# MESA ENGINEERING

Date: August 19, 2008  
 To: West Park PUD Neighbors  
 From: Bruce Melton, P.E., Oak Hill, Texas  
 Re: Implications for Development Buildout, West Park PUD

## Oak Hill Traffic Comparison

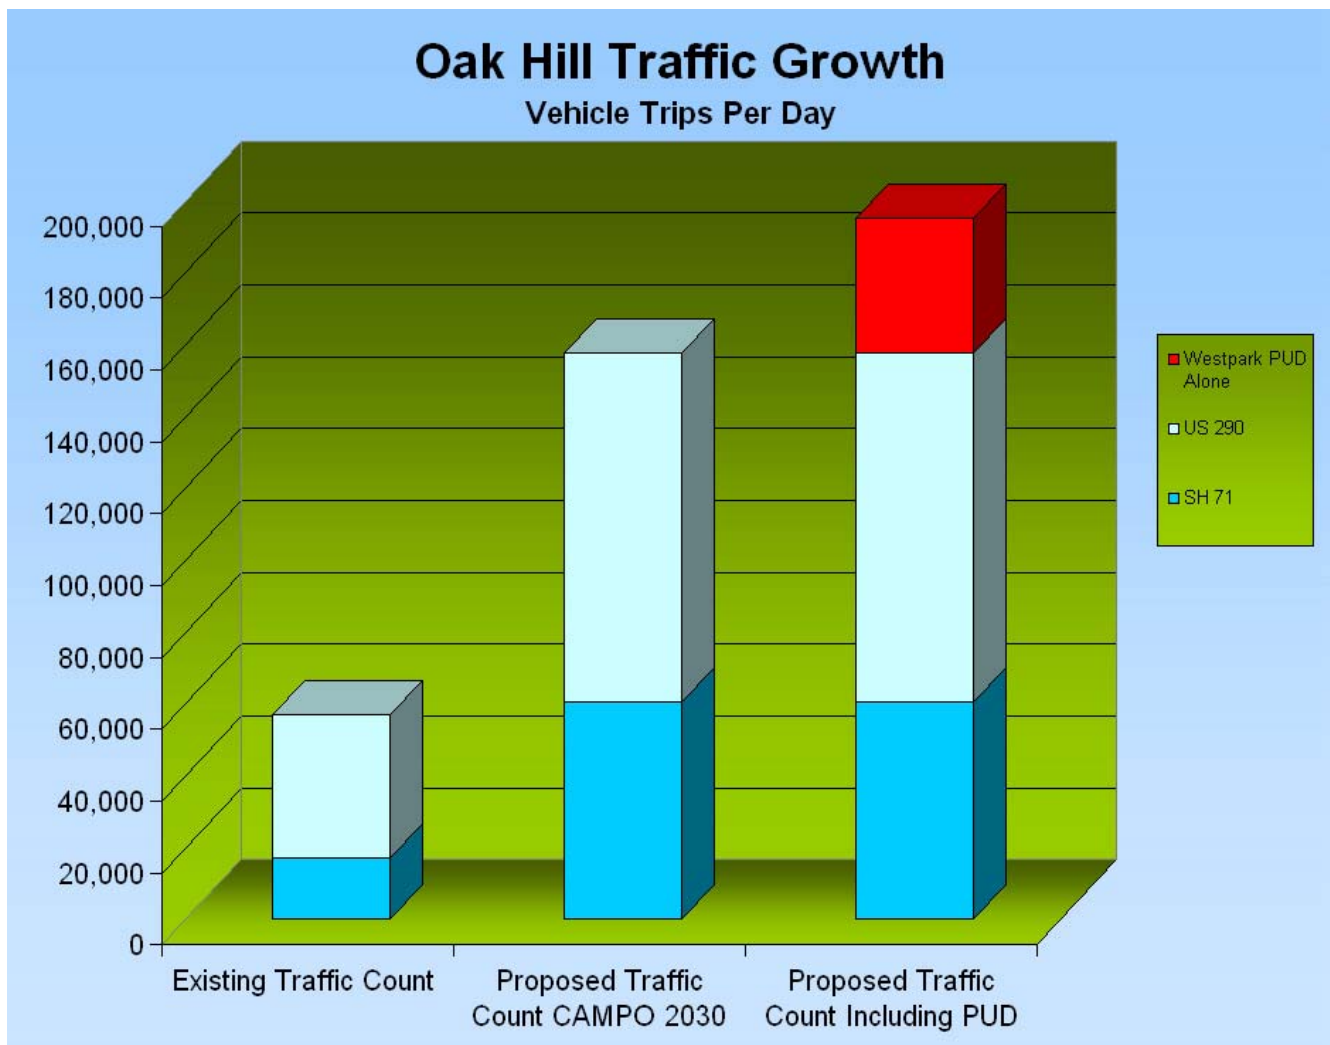
- 4) This “mega development” poses extreme implications for traffic congestion in Oak Hill as shown in the chart below:

- 7) **EXTREME CONGESTION – FAILING LOS:** TxDOT’s frontage road level of service or LOS (amount of congestion) for their 12-lane section fails badly because of tolling. The frontage roads fail long before 2030 because CAMPO has determined that 33% of all traffic will use the frontage roads to escape tolling. The improvements that are proposed in this project’s Traffic Improvement Analysis do nothing towards mitigation of this extreme congestion issue. Once this development opens, traffic congestion will immediately fail on the frontage roads leading to even more congestion in Oak Hill than exists today.

- 8) **TWO LANE FORNTAGE EACH DIRECTION - CURRENT PROPOSAL:** TxDOT’s new alternative that meets Army Corp, TCEQ and USFW requirements has been suggested by TxDOT to have a 10-lane cross section, with two frontage road lanes in each direction. Obviously, with one third less capacity, and so much traffic using the frontage roads as defined by CAMPO, this development will create traffic congestion in Oak Hill, that - even after TxDOT completes construction – is significantly worse than congestion experienced in Oak Hill today.
